FROM: Michael Mobile, Ph.D., McDonald Morrissey Associates, LLC

TO: Daniel C. Hill, Esq., Hill Law

DATE: December 29, 2020

SUBJECT: **Technical Review of MODFLOW Model and Associated Mounding Analysis Presented in Support of the Proposed Hanover Weston Development, Weston, Massachusetts**

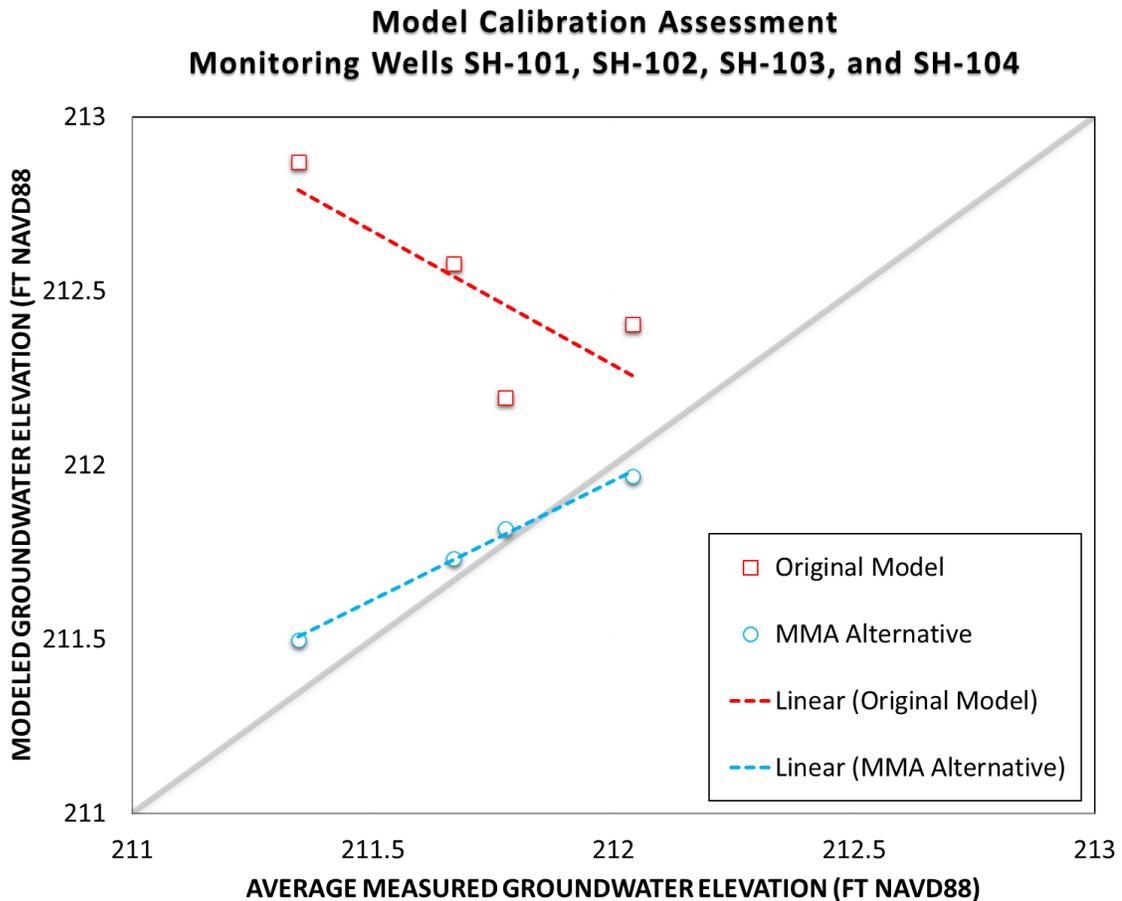
- The vertical thickness of the model was adjusted and applied to a redesigned finite-difference grid using local high-resolution topographic elevation data (i.e., LIDAR)<sup>4</sup> to define the top of the model and the test pit and boring log information contained within the SHA Hydrogeo Report to define the bottom of the model.
- Test pit and boring log information was used to support adjustment of the simulated extents of the “sand and gravel” and “glacial till” soils.
- In addition to developing a revised no-flow boundary at the bottom of the model domain, as noted above, a new set of perimeter boundary conditions was developed to be consistent with the following conceptualization of key local system characteristics:

- Whereas the primary local source of groundwater is precipitation recharge, the primary local sink (i.e., discharge mechanism) for groundwater is outflow to the eastern stream and wetland complex area. Since a reasonable approximation of the controlling elevation of the wetland area can be derived from LIDAR data, it is reasonable to represent this area as a head-dependent boundary using the MODFLOW Drain (DRN) Package.

- Smaller exchanges of groundwater and surface water are possible within the section of the stream located to the north. Stream elevations can be approximated based on LIDAR data; therefore, it is reasonable to represent the section of the stream draining to the wetland area as a head-dependent boundary using the MODFLOW General Head Boundary (GHB) Package.

- It is reasonable and conservative relative to mounding potential to assume a groundwater divide coincides with the position of the sub-basin divide to located to the west. Assuming the position of the groundwater divide remains static, it is reasonable to treat this area as a no-flow boundary in MODFLOW.

Modeled Mounding Height Near Western Limit of Proposed Primary Wastewater Disposal Area

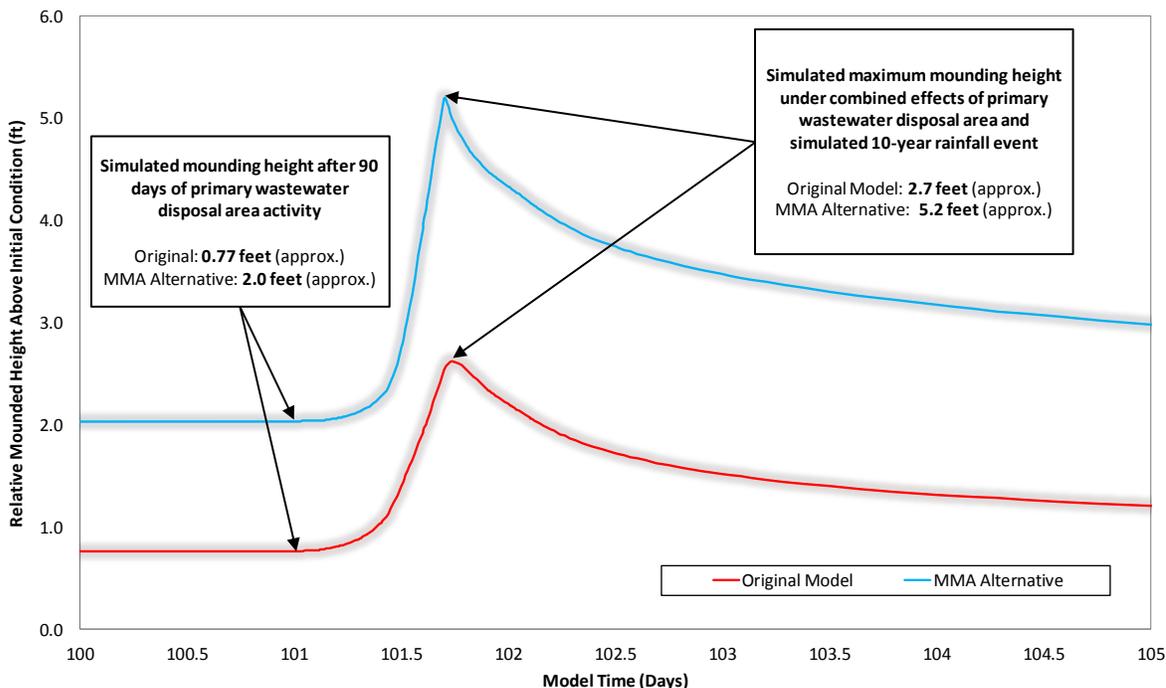
Finally, by comparing the results derived from transient simulations representative of the proposed primary wastewater disposal area, it is clear that Category 1 issues contribute significantly to low bias in mounding simulated by the original model. The following figure highlights the difference occurring at the time where mounding heights peak in both simulations:

As identified in the figure, the original model results are consistent with the 2.7 feet of simulated mounding referenced on page 9 of the SHA Hydrogeo Report (location noted to be near the upgradient southern extent of the proposed primary wastewater disposal area). However, when the same scenario is simulated with the alternative model developed by MMA, the resultant peak mounding height doubles to more than 5 feet.
